RESPONSE TO REQUEST FOR ADDITIONAL INFORMATION

APR1400 Design Certification

Docket No. 52-046

RAI No.: 530-8714
SRP Section: 10.3 – Main Steam Supply System
Application Section: 10.3
Date of RAI Issue: 11/21/2016

Figure 10.3.2-1 Main Steam System Flow Diagram (1 of 2)

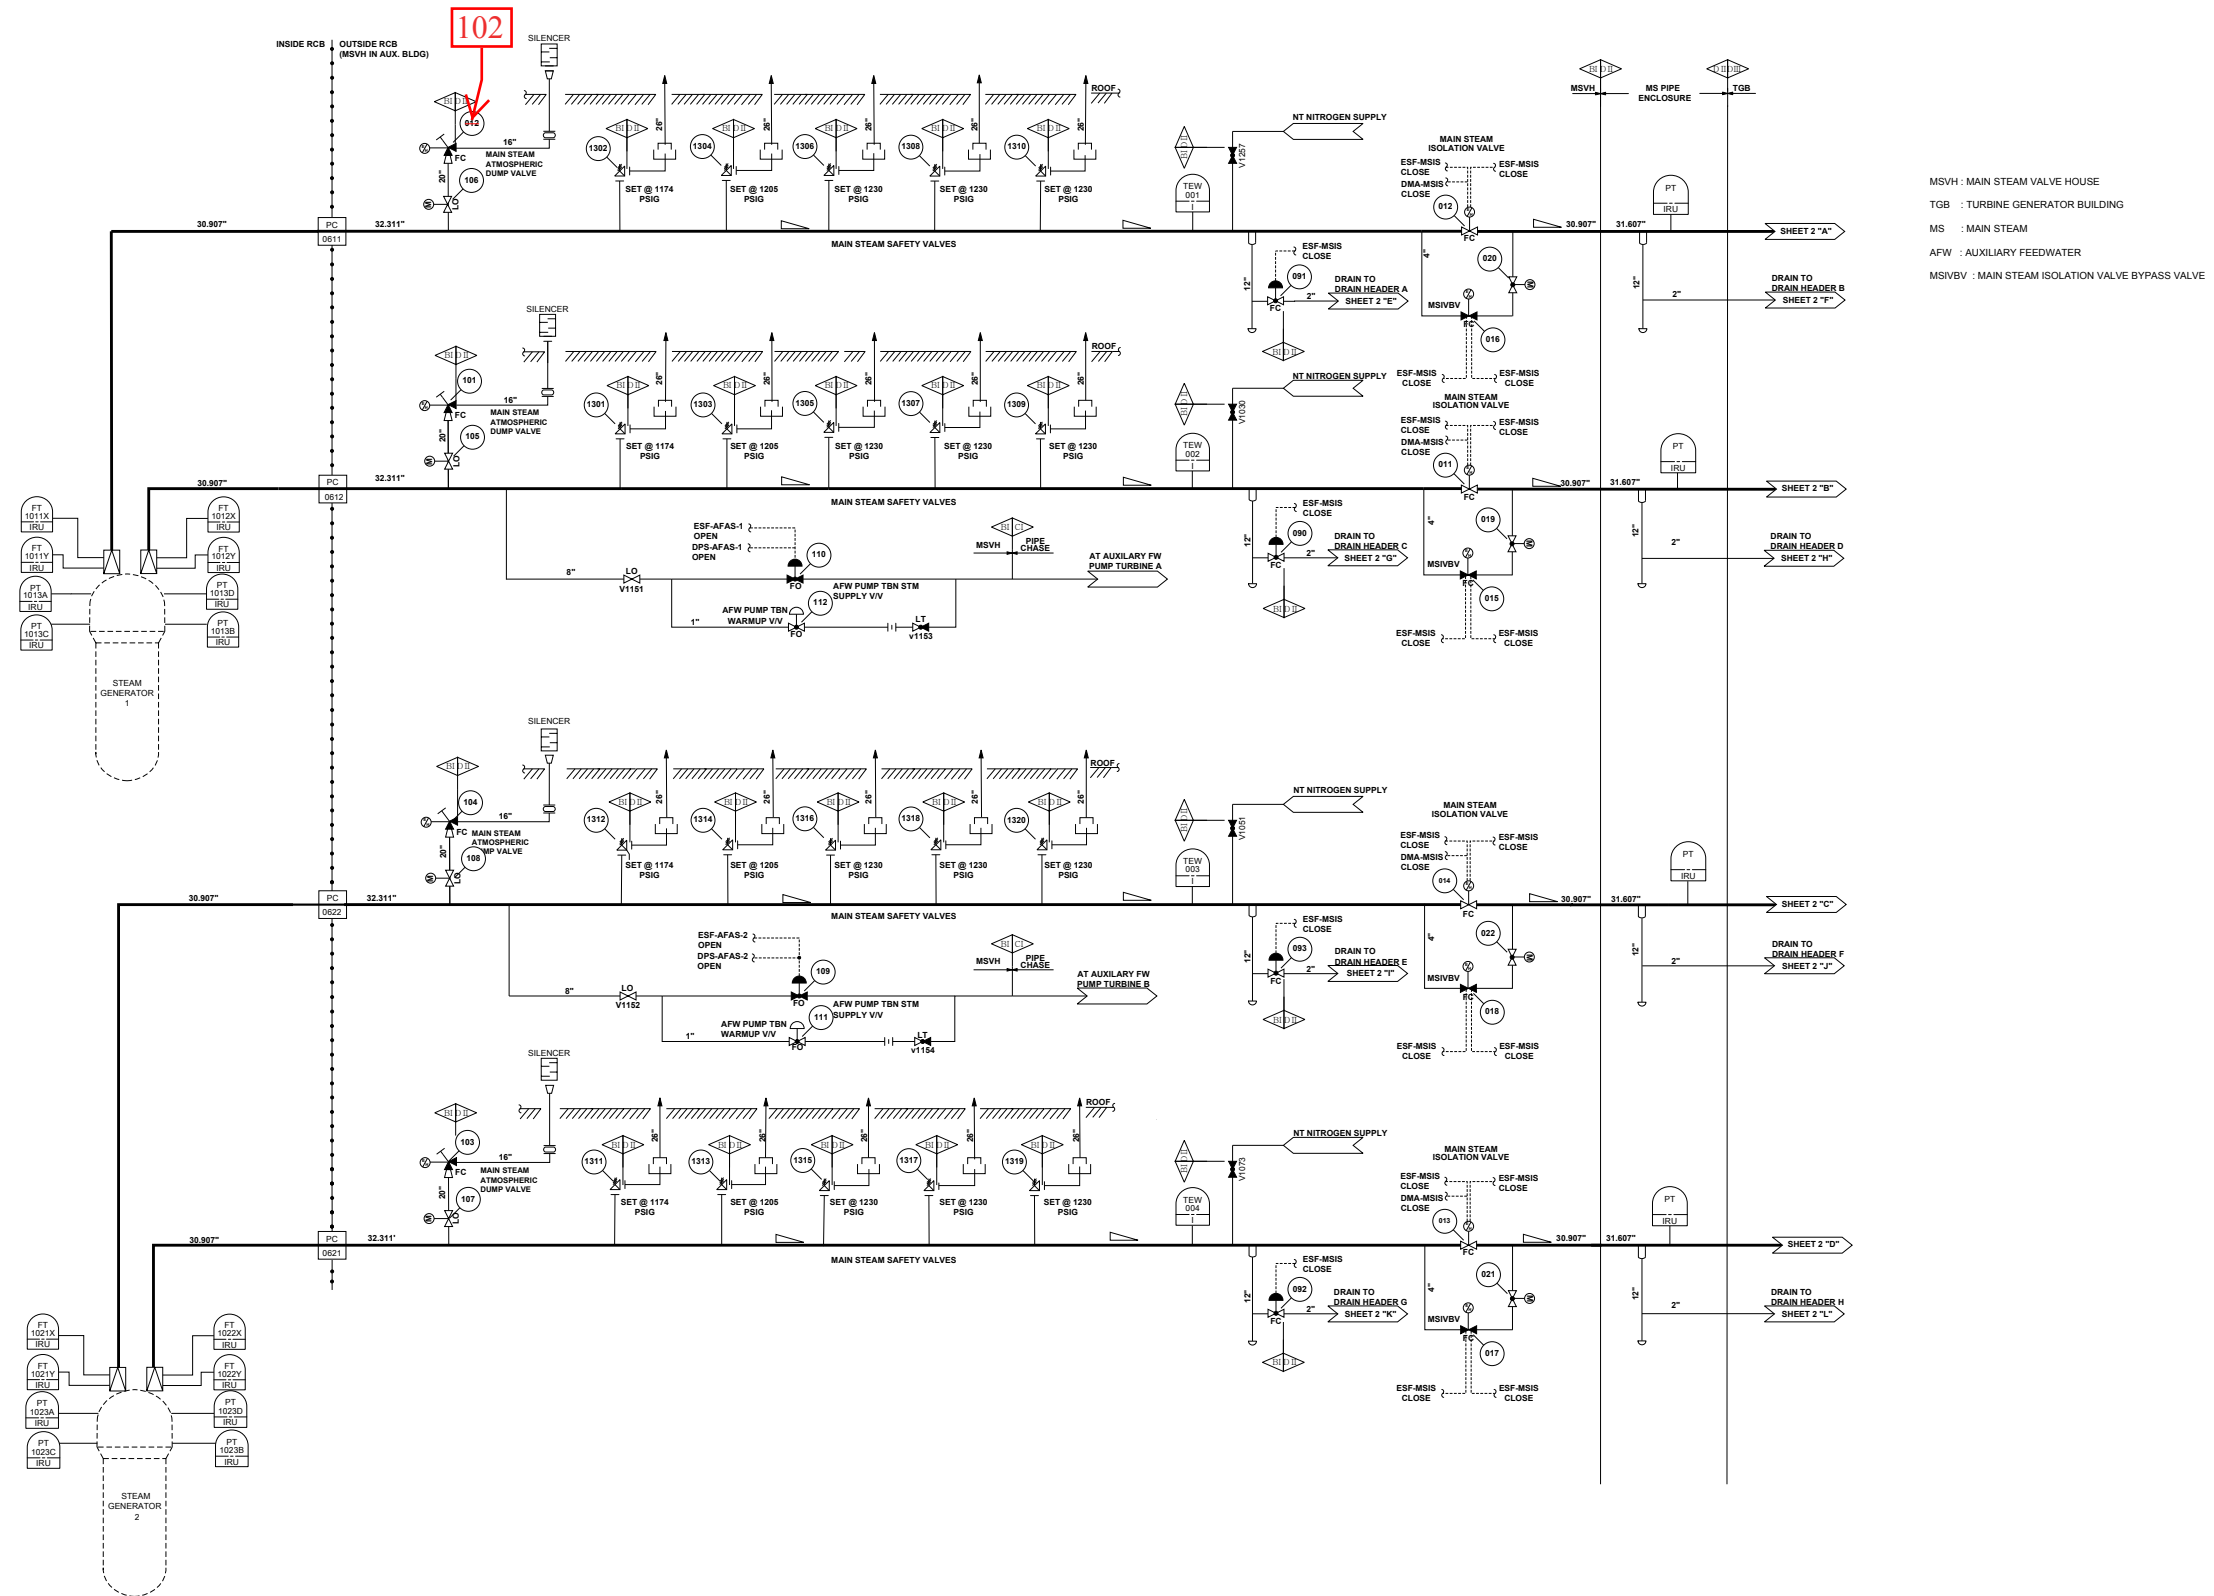
The staff also notes that DCD Tier 2, Figure 10.3.2-1, “Main Steam System Flow Diagram (1 of 2),” identifies the MSADV on main steam line #1 from steam generator #1 as valve no. 012. The staff believes this MSADV should be identified as valve no. 102. The applicant is requested to

review Figure 10.3.2-1 and make any necessary corrections in order to ensure consistency with the DCD.

In Figure 10.3.2-1, valve No. 012 will be revised to No. 102 as indicated in the attached markup.

DCD Tier 2, Table 10.3.2-3 and Figure 10.3.2-1 will be revised as indicated in the attachment.
